CERTIFICATE OF APPROPRIATENESS APPLICATION FORM

701 W HISTORIC MITCHELL ST Milwaukee, WI 53204

We want to correct the bricks falling off from building.

Subject wall for partial demolition.

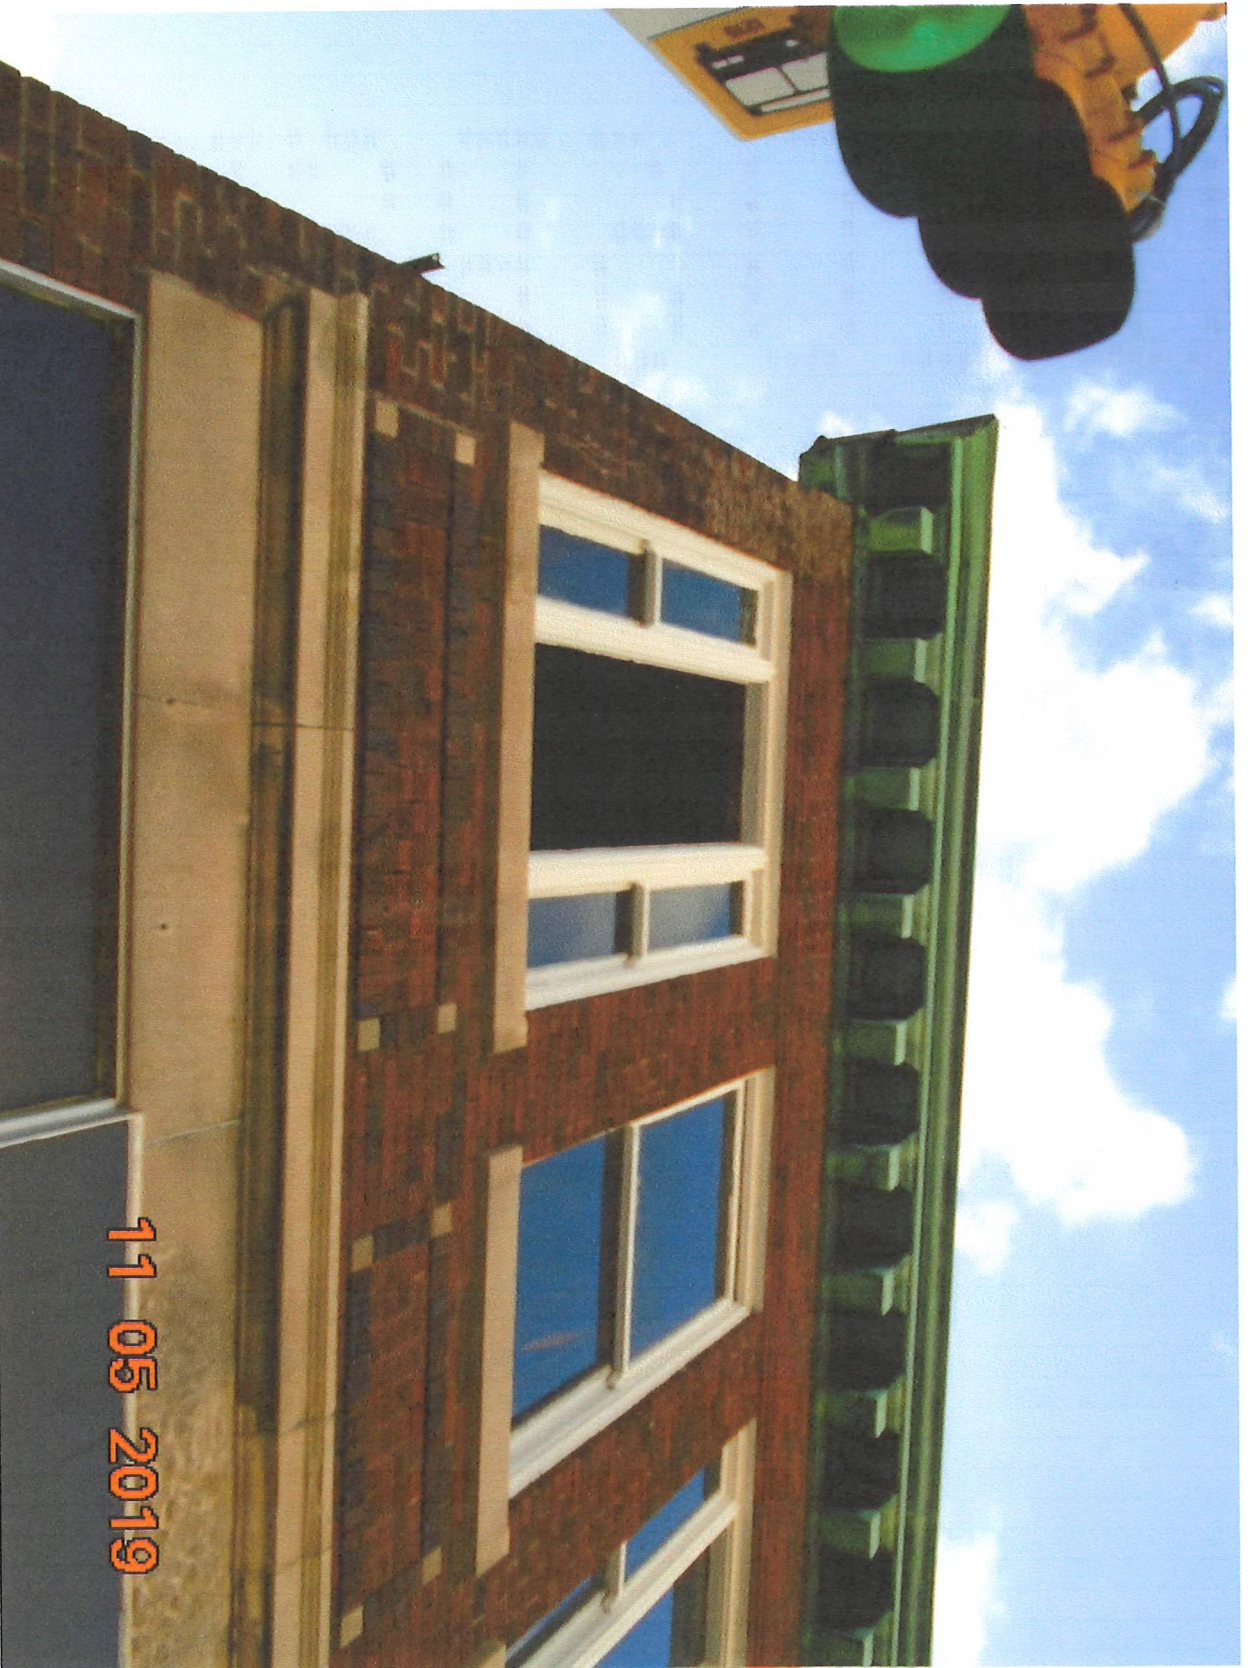
Detail of damaged area. Note subtle pilasters and copper coping. Pilasters and copper coping will be required in the reconstruction.
